MCCRARY AUTOMOTIVE SUBDIVISION

APPLICATION NUMBER 4 DATE July 16, 2020

REQUEST Subdivision

DETAIL SITE PLAN

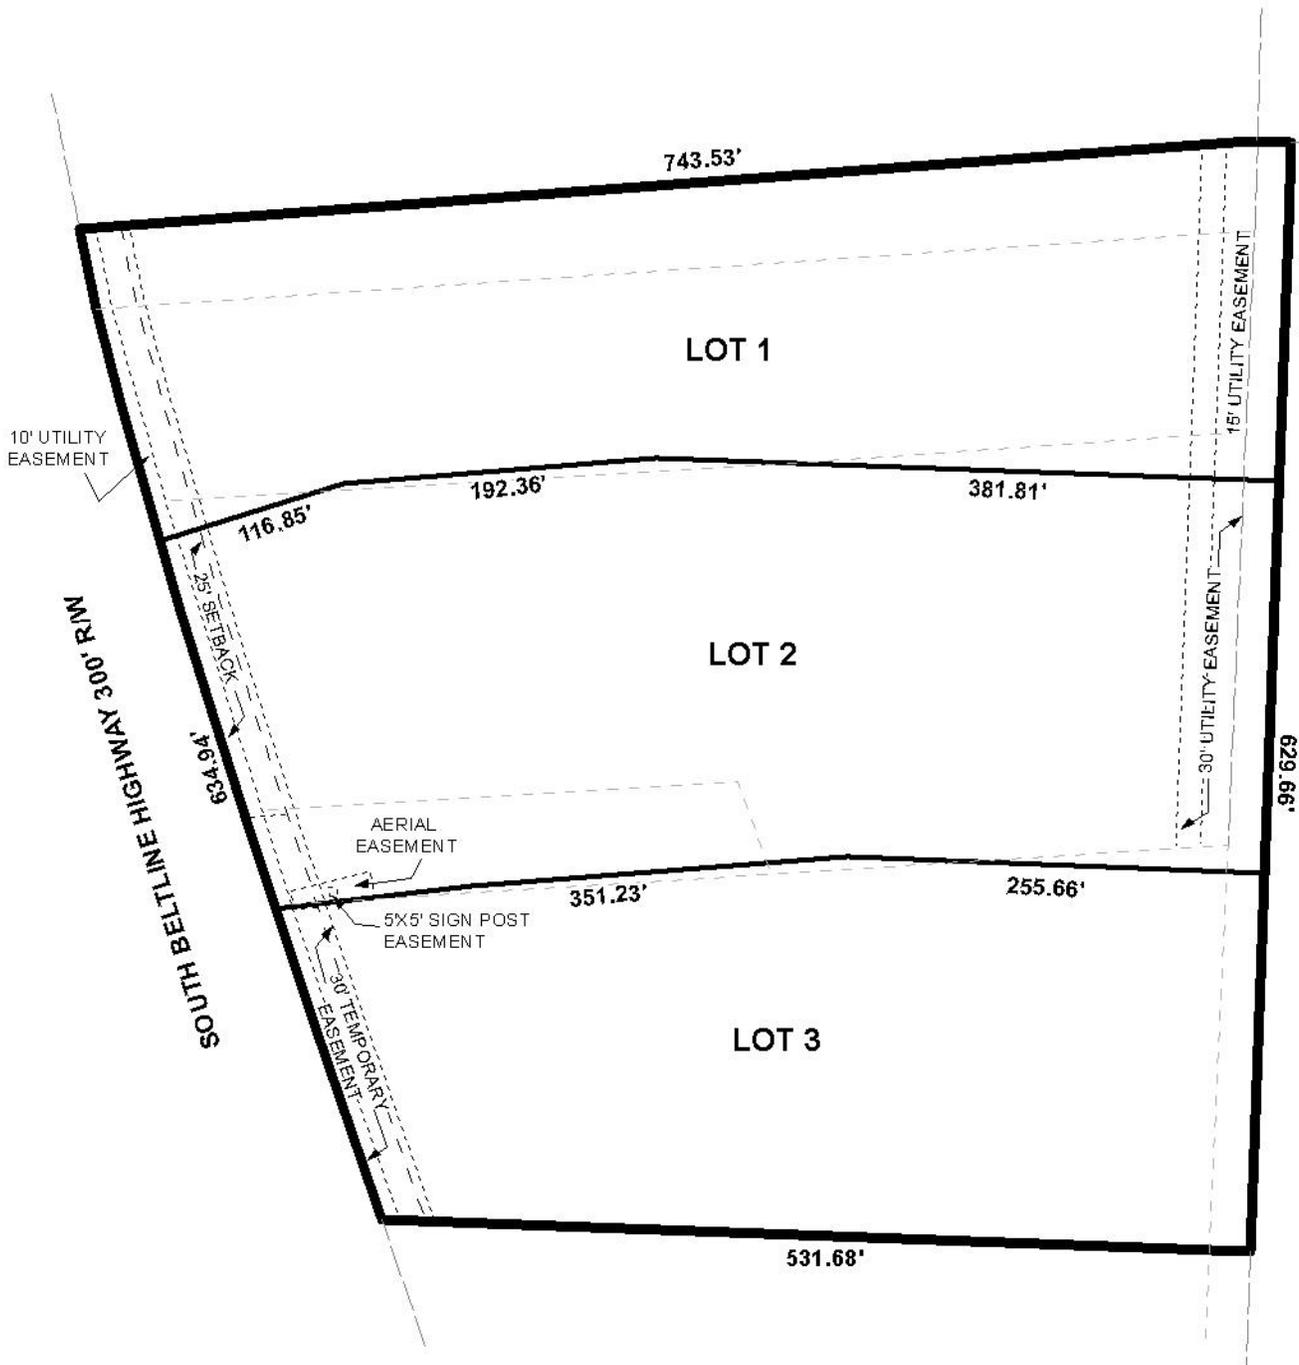
- A. Provide all of the required information on the SUBDIVISION PLAT (i.e. signature blocks, signatures, certification statements, written legal description, required notes, legend, scale, bearings and distances) that is required by the current Alabama State Board of Licensure for Professional Engineers and Land Surveyors.

- B. Provide reference, on the map and the description, to a monumented corner.
- C. Provide a LOT designation for each of the three (3) new LOTS (i.e. A, B, C, 1, 2, 3) other than “NEW LOT 1, NEW LOT 2, AND NEW LOT 3”.

- D. Show and label all flood zones, including X (shaded). New maps went into effect on June 5, 2020.
- E. Show and label the MFFE (Minimum Finished Floor Elevation) on each lot that contains an AE, V, or X (shaded) flood zone designation.

- F. Clarify the recording data for the “30’ Temporary Construction Easement (Case #21,752)”. What is “Case #21752” mean?
- G. Provide the Surveyor’s and Owner’s (notarized) signatures.

The site fronts I-65, a component of the Major Street Plan with a planned and current 300' right-of-way; therefore, no right of way dedication would be required. The plat indicates a variable right-of-way width along the site frontage and should be revised to indicate at least the minimum existing right-of-way.

The plat indicates a recorded 25' minimum building setback easement along the front of the site. This should be revised to also label this line as the 25' minimum building setback line. Other easements are also indicated within the site; therefore, a note should be required on the Final Plat stating that no structure may be constructed or placed within any easement. The plat labels the new lots as "New Lot 1", "New Lot 2" and "New Lot 3". These labels should be revised to label the lots as "Lot 1", "Lot 2" and "Lot 3". The lot size labels should be retained on the Final Plat, or a table should be furnished on the Final Plat providing the same information.

- 1) revision of the plat to include the existing minimum right-of-way width for I-65;
- 2) revision of the plat to label the 25' minimum building setback easement as the 25' minimum building setback line;

- 3) placement of a note on the Final Plat stating that no structure may be constructed or placed in any easement;
- 4) revision of the plat to label the lots as "Lot 1", "Lot 2" and "Lot 3" and not "New Lot 1", "New Lot 2" or "New Lot 3";

- 5) retention of the lot size labels in both square feet and acres on the Final Plat, or the furnishing of a table on the Final Plat providing the same information;
